Proposal for Supplement [2] to the 00 series of amendments of Regulation No. 128

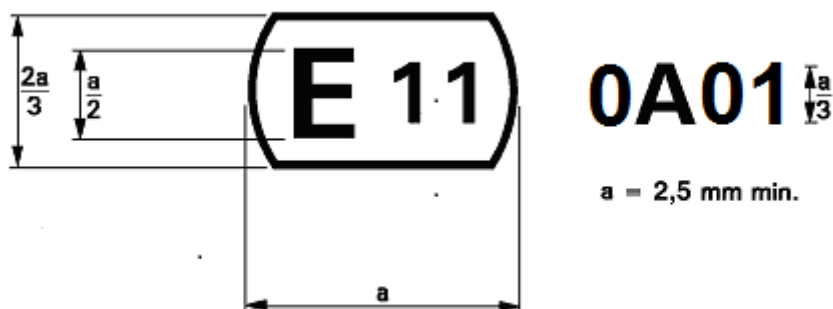
Paragraph 2.4.2., amend to read:

"2.4.2. ... This will be followed by an identification code comprising not more than **three** characters. Only the following Arabic numerals and capital letters shall be used:

"0 1 2 3 4 5 6 7 8 9 A B C D E F G H J K L M N P R S T U V W X Y Z". .."
